WARRANTY BULLETIN

Campaign no.: 2020-0005

Subject: **Spyder® RT - Abnormal Gaps Around the Rear Cargo Module Access Covers**

No. **2020-3**

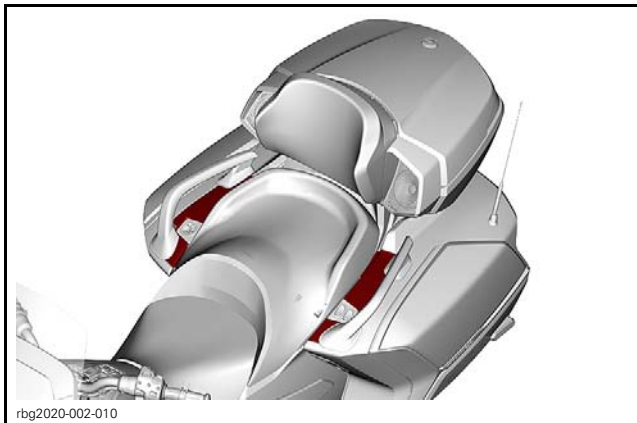
The interference between access covers and frame prevent mounting holes alignment. This situation creates abnormal gaps around both rear cargo module access covers.

Abnormal gaps are present between both rear cargo module access covers and adjacent body parts.

To minimize the gaps, only the access cover rear screw was installed from factory.

The front was intentionally secured with a locking tie instead of a screw.

1. Locking tie

Replace both access covers and install screws instead of the locking ties.

rbg2020-002-001

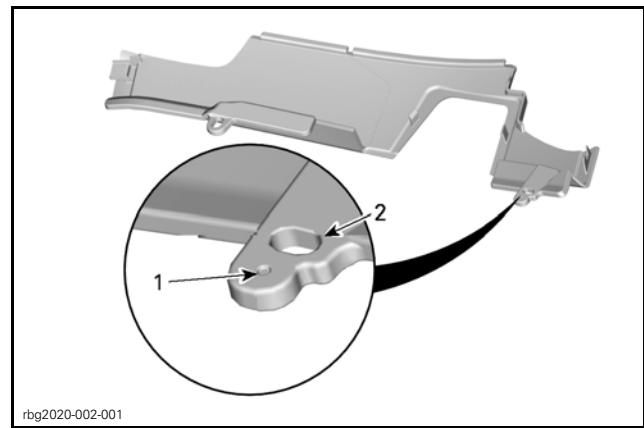
1. Remove the passenger seat.
2. Cut the locking tie securing the front of the access cover.
3. Remove and keep the rear screw.
4. Remove and discard the access cover.
5. Turn the new access cover upside down.
6. Using a 5mm drill bit, drill a hole on the front tab, under the front slotted hole.

1. Molded dot where drill
2. Front slotted hole

7. Position the access cover and loosely install the previously removed screw and a new K50 x 16 Torx screw.
8. Move the access cover to have an equal gap in back and in front.
9. Hold the access cover in this position and tighten screws.

TIGHTENING TOQUE	
Access cover screws	2.75 N•m ± 0.25 N•m (24 lbf•in ± 2 lbf•in)
